Project name **Station Hill Phase 1**
Project no. **1620004716**
Client **PIC E&F PROPCO LLP**
To **Reading Borough Council**
From **Keith Jones**

Storm Water Drainage Supplementary Memo

Date 05/05/26

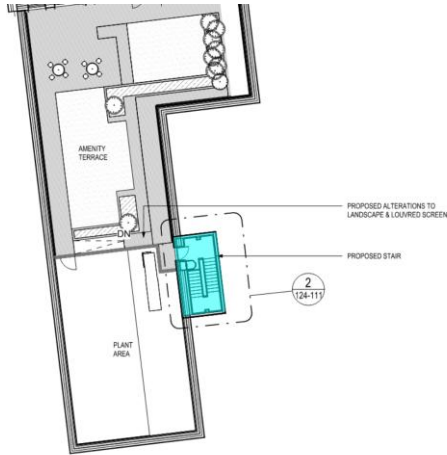
The existing condition is for any surface water at the rear of block F be collected in the lower ground gullies and fed into the below ground attenuation network via Tank C, then discharged into the public network via the flow controlled connection on Garrard Street. The route is highlighted below in the extract from Ramboll drawing SHR-RMB-ZZ-ZZ-DR-C-03-000111.

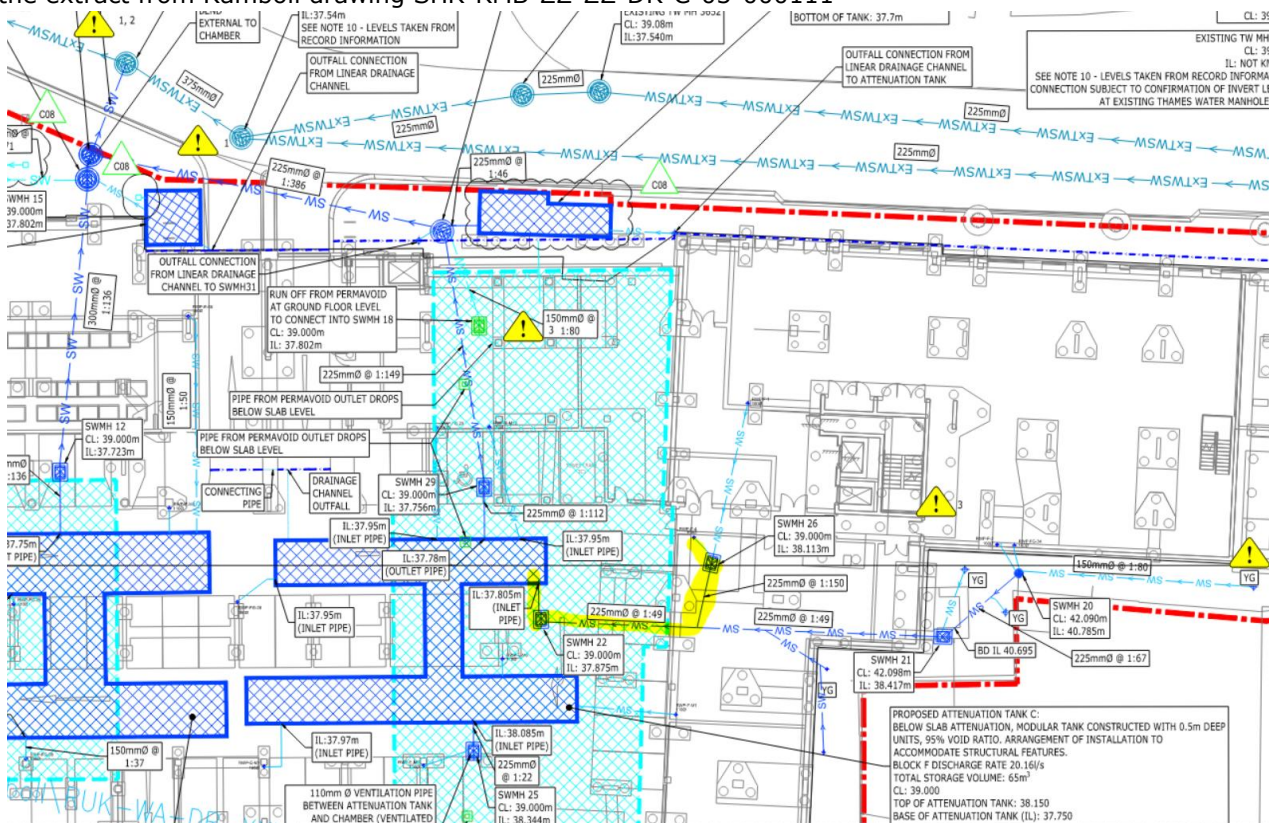
The introduction of the additional escape stair to the rear of Block F means that an area of approximately 18m² (3m by 6m) on plan, highlighted in blue, will drain from the roof of the escape stair onto the existing roof of Block F.

The existing drainage of the roof area is via two roof gullies (RWP-F-4 and RWP-F-5) to the north and south of the existing roof area. The existing roof area is approximately 405m² and therefore the additional 18m² represents a 4.5% increase in roof area to be drained by the two roof gullies. This change in area is considered negligible for the design of the above ground drainage network RWP-F-4 and RWP-F-5.

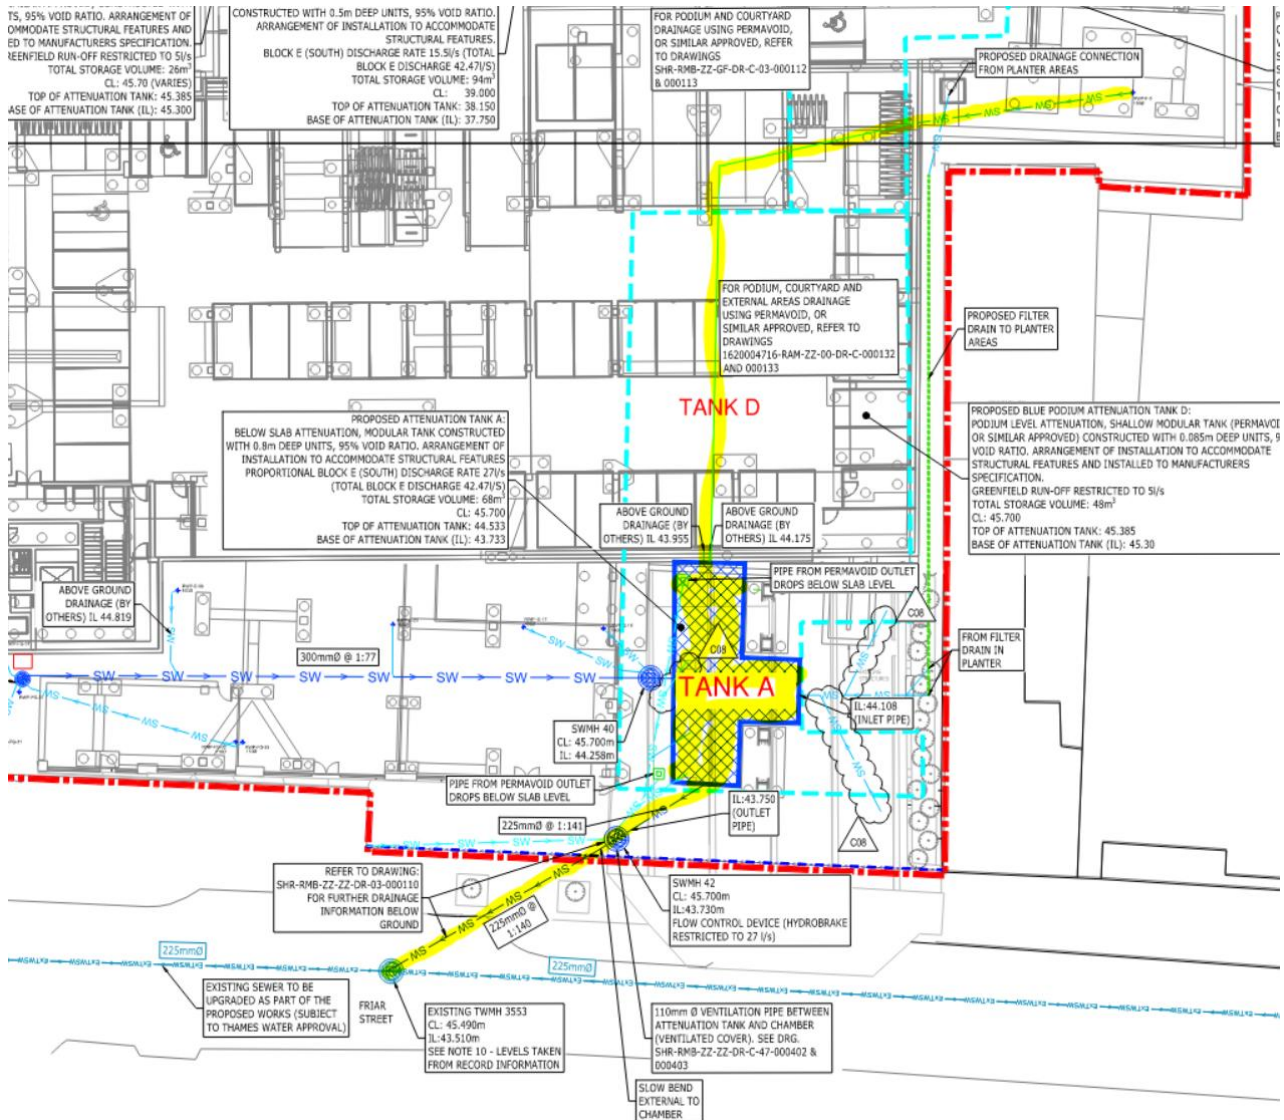
The RWP-F-4 above ground network feeds into the same attenuation tank C as the existing gullies to the rear of Block F. Hence no impact on the below ground drainage. The route is highlighted below in the extract from Ramboll drawing SHR-RMB-ZZ-ZZ-DR-C-03-000111
